ASSESSMENT REPORT

Section 75W Modification Materials Recovery Facility (06_0052 MOD 2)

Figure 2 – Approved Site Layout (as modified)

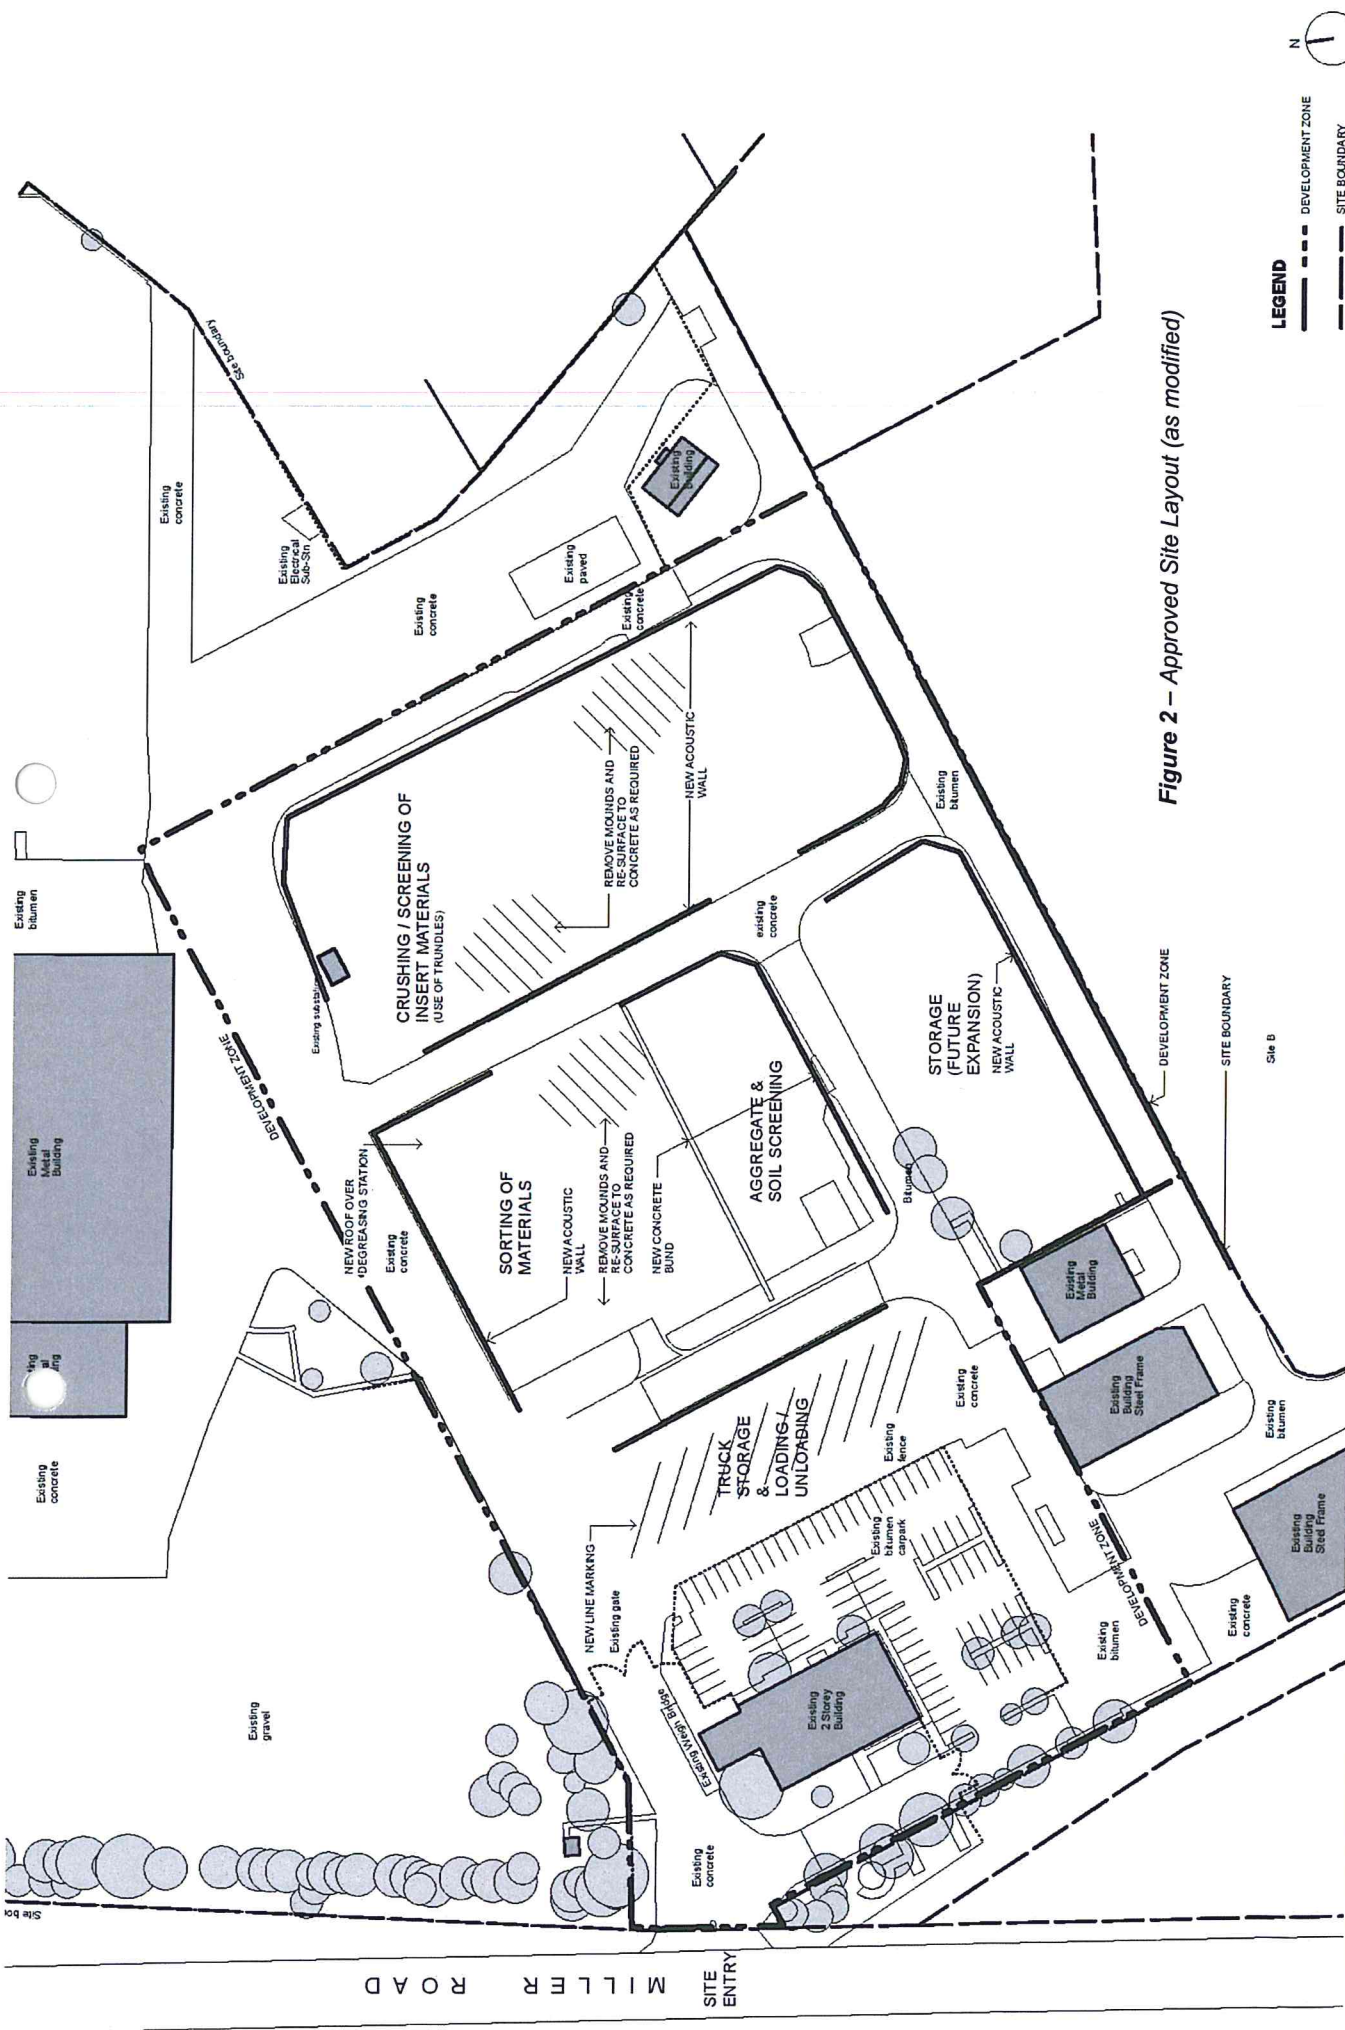
The modification proposal involves placing shipping containers on the site permitter only, where they are intended to function as acoustic barriers for the approved operation. However, the approved barrier layout included a number of internal barriers, which were required to segregate stockpiled material on the site.

Without the internal barriers, it would be difficult to manage stockpiles and separate waste in an orderly manner. The operation of the MRF without the internal barriers has led to a range of compliance issues including dust emissions, excessive stockpiles heights, stormwater contamination and the uncontrolled ignition and burning of waste. In addition, there is a significant risk of cross-contamination between raw materials and processed product.

container stacks. The container stacks are only 5m high, whereas the approved concrete barriers are required to be 8m high on the northern perimeter of the site to ensure that activities at the premises are shielded from the noise sensitive receivers to the north.

Figure 9 – Misaligned container stacks

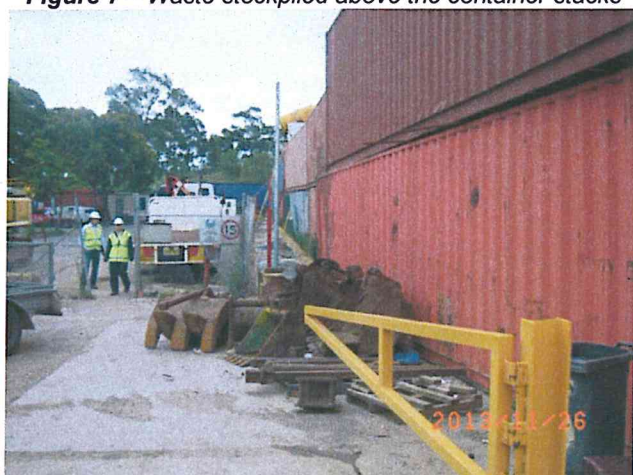
The visual impact issues for the proposed modification are two-fold. The containers are insufficient to screen operations of the premises, as can be seen in **Figure 7**. In addition, the container stacks are sometimes misaligned, painted various colours and often in poor physical condition as can be seen in **Figures 8, 9 and 10**.

Further, the containers are in very poor condition and have been placed on the site in a haphazard manner. They are painted various colours and the whole effect is one of very high visual discordance, which is unacceptable for a permanent installation.
